APPENDIX 6 - FOR INFORMATION
SEVENOAKS - HARTSLANDS ROAD & SANDY LANE - PARKING PROPOSALS
Description and plan of parking proposals, feedback from the statutory consultation and Officers' comments and recommendation

PARKING PROPOSALS FOR HARTSLANDS ROAD & SANDY LANE, SEVENOAKS

SEVENOAKS - Hartslands Road & Sandy Lane

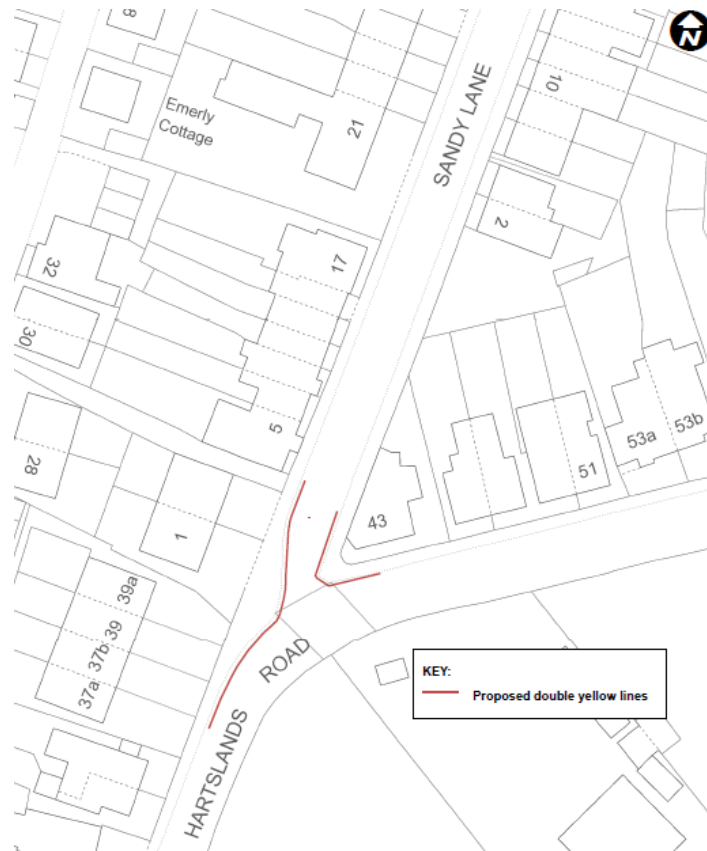
1. Parking there is dangerous and obstructs visibility.
2. It would be much safer for my children walking to and from school with better visibility.
3. We would also suggest that double yellow lines are put on the inside of the bend opposite Sandy Lane as cars are increasingly parking on the blind bend. One also needs to be careful that the double yellows do not extend too far east

along Hartslands Road to the extent of preventing two cars parking before the drive way of number 43 Hartslands. This will force cars to park on both sides of the road, which in our view makes the road dangerously narrow. We would also encourage the consideration of parking permits in the area.

1. Increased danger to road users, loss of parking, unnecessary scheme and damage to Conservation Area
2. Safety - will push parking to other side of road on a blind bend. Cars already park there creating issues should emergency vehicles wish to access Hartslands Road. Parking - already high volume of cars in road meaning they will be forced elsewhere. Will restrict visibility on leaving/entering our driveway. We believe double yellow lines should be on the other side of the road which is where the greatest danger is currently. These proposed double yellow lines will create huge problems which we believe will be made worse once commuters return to the area.

3. I believe that with the 20mph limit in place the yellow lines as shown on the plans will only restrict residents parking which is already very limited. Instead yellow lines are needed on the southern and west sides of Hartslands Road to prevent emergency vehicles being unable to get through which is what happens when non residents park here forcing residents, many of whom have young children, to park there. Residents parking in this area is, as you are aware, a problem and more needs to be done, such as residents parking permits with a 2 or 4 hour limit for non residents. I recognise that this would increase the scope of work for traffic wardens and the associated costs but also believe that it would deter many from parking here all day which is the main problem.

4. One of the stated reasons for this proposal is: - improving local on-street parking availability and on-street parking for disabled people. However, in the Hartslands Road example, the proposal significantly reduces available on-street parking for residents in a road where parking availability for residents is already limited. Alternative measures should be considered including marked parking bays set diagonally to the pavement along the widest sections of Hartslands Road, a parking permit scheme for when the pandemic ends (and commuting restarts) and a one way system to facilitate diagonal parking taking up a greater proportion of the available space on the road.

5. I think this proposal is short sighted as a resident in Sandy Lane for the last 14 years. The parking in Sandy lane is already difficult and reducing the places people can park will only lead to congestion on the other main routes. The

issue with access to the road exists with Hartsland and the huge van that parks here all the time although nothing is done. We are in a conservation area so I think this is also against the rules. Our children walk to schools and the thoughts of cars being crammed into a smaller area causes more worries. Equally Quaker hall lane needs the focus not this area.

6. I have lived in Sandy Lane for 20 years and we have never had a problem with parked cars blocking the end of the Lane. Parking is VERY limited in this area so removing so many spaces would cause a huge problem. The junction is wide and open. The traffic flows freely. There is no difficulty getting out of Sandy Lane into Hartslands Road. As far as I am aware there has never been an accident on that corner. At the moment, people ease around the corner from Hartslands into Sandy, but remove the parked cars and it'll become an even faster rat-run than it already is. No one takes a blind bit of notice of the 20mph limit which now covers our area. Reduced parking where Sandy meets Hartslands is not what we need. We need enforcement of illegal parking on the double yellow lines at the Quaker's Hall end of Sandy Lane and enforcement of the speed limit. I just can't see the sense in it. Two cars can pass on that corner of Hartslands even with cars parked there.

7. I am writing to register my objections to the proposal to install double yellow lines at the junction of Hartslands Road and Sandy Lane as set out in Formal (Statutory) Consultation - Minor Parking Proposals - TRO 2013 Amendment 36. My objections are based on the considerations below:

- i) The proposal to install double yellow lines at this junction runs contrary to the Planning Guidance set out in the Hartslands Conservation Area Appraisal and Management Plan as approved by Sevenoaks District Council in 2011. The proposal does not meet the Core Strategy as it applies to Conservation Areas as a whole, the 'Saved policy' EN23 as it applies to Conservation Areas, and the particular requirements of the Hartslands Plan.

The Hartslands Area is described as being 'on an intimate domestic scale' with 'a strong sense of place and cohesion'. The junction at Hartslands Road and Sandy Lane is particularly important. It is identified in the map accompanying the appraisal document as being a significant view point. The Guidance makes clear that such public views should be protected (S.5.4). In respect of the property at 43 Hartlands Road, the appraisal document notes. 'The prominently located white painted corner building is an important feature within the street scene.' (S.4.3). Double yellow lines at this important corner could only be a jarring feature and thus detrimental to the public realm.

- ii) The proposal to install double yellow lines at this junction seems unnecessary. Given the angle of the junction, all vehicles need to be travelling slowly at this point whether turning into, or pulling out of, Sandy Lane. The recent (very welcome) decision to impose a 20 mph speed limit on both roads gives that additional legal force. Bollards previously installed at the western side of this junction already prevent pavement parking.

- iii) The proposal to install double yellow lines at this junction could increase traffic dangers. Anything that encourages vehicles to speed up at this point leads to an increased risk of collision given the sharp turn taken by Hartslands Road just before the junction. And anything that highlights the junction by outlining it in yellow might encourage vehicles coming from the south end of Hartslands Road to see it as a potential short cut to Quakers Hall Lane. Sandy Lane is a narrow lane not conducive to two way traffic, particularly at the lower northern end which is only the width of one vehicle. Currently it is a quiet road normally only used for access. An increase in through traffic would increase the risk of vehicles encountering each other at the lower end of the road. If this happens, one or the other has to back up the length of 10-12 houses or back out onto Quaker Hall Lane with all the risks that entails. For these reasons, I ask that the proposals be looked at again. I feel strongly that no decisions should be taken until the planning authority has taken a view on the impact on the Conservation Area. I look forward to hearing their views. A joined up approach is needed in this 'unique compact Victorian Neighbourhood'. The ad hoc imposition of double yellow lines does not provide an adequate solution in terms of the pressure of moving and stationary vehicles and would be very damaging to the Conservation Area as a whole.

8. There is huge unfulfilled demand for residents parking in the Hartslands area, so there should never be net removal of parking spaces. Any removal of any spaces, as here, must be balanced by the creation of at least twice that number of new ones, which is easily possible if SDC holistically looks at the whole Hartslands parking issues rather than following its constant, micro-management, sticking plaster approach. Now the area is a 20mph zone, vehicle speeds are lower so there is less danger posed by on-street parking. Part of the issue in this location appears to be cars being parked over residents' access/dropped kerbs to their property. A single solid white line should be used in these locations, not double yellow, as this allows those residents to park across their accesses, if they wish, which hence removes parking pressure elsewhere. Your Leader, Peter Fleming, has frequently derided his officers for making the mistake of using double yellows in these situations, rather than solid white lines, so please listen to your Leader, as well as local residents in this case. The double yellow lines proposed on the east (acute angle) side of

the junction are totally excessive and, apart from arguably a few metres on the actual corner, are not needed. They remove 3-4 on-street parking spaces, which cannot be afforded in the area. Similarly, on the West side, not all the length of proposed line is needed, as 1-2 cars can park perfectly safely against the build-out without affecting traffic flow or access to Sandy Lane. Yet again, this is SDC using a sledgehammer to crack a nut. I suspect the main reason why SDC is seeking restrictions in this location is to allow it to send a too large refuse collection lorry into Sandy Lane - the obvious solution is to send a smaller lorry, as is done in other roads.. Once again, SDC is asked to strike up constructive dialogue with Hartslands' residents about parking needs in the area, and not take a piecemeal, negative approach, as here. Pls contact me to start setting up fully inclusive dialogue meetings with local residents to take a holistic view of parking needs. Whilst this dialogue takes place, this double yellow line application must be refused.

9. The proposed double yellow lines will create danger in the area by further restricting parking. We believe cars will park on the other side of Hartslands Road, on the blind bend (as already occurs). When this happens it is very difficult for an emergency vehicle to pass. The double yellow lines would be better situated on the opposite side to the proposed restrictions. We also believe that cars will park closer to our driveway meaning access and line of sight will extremely difficult and causing further danger. Again, due to the absence of parking in the area, this already happens. In our view these proposals should be rethought to avoid danger to life being caused by displaced parking.

10. By placing double yellow lines on the proposed part of the bend in the road on Hartslands Road it will encourage cars to park on the inside bend (opposite the junction) which is far more dangerous and will cause cars to swerve around cars parked on the inside of the bend.

11. Removing the ability to park along the Eastern side of Sandy Lane and around that bend into Hartslands Road will mean that parking is even more difficult outside of my house, as the cars that usually park there for Sandy Lane are forced to use Hartslands Road instead. However, I agree that the line along the Western side is a good idea.

One of the main reasons for the proposal to install parking restrictions at the Hartslands Road/Sandy Lane junction is to improve the efficient movement of traffic using the junction, especially large vehicles, such as refuse freighters and

fire tenders, by protecting it from parked vehicles. This in turn supports the advice given in Rule 243 of the Highway Code about not parking on junctions.

There is also a pedestrian dropped kerb at the junction, which the proposed restrictions would protect from parked vehicles.

However, the concerns raised during the statutory consultation about the impact of the proposals, particularly on local parking availability and the conservation area as a whole are acknowledged.

It is recommended that the objections be upheld, and this particular proposal be withdrawn
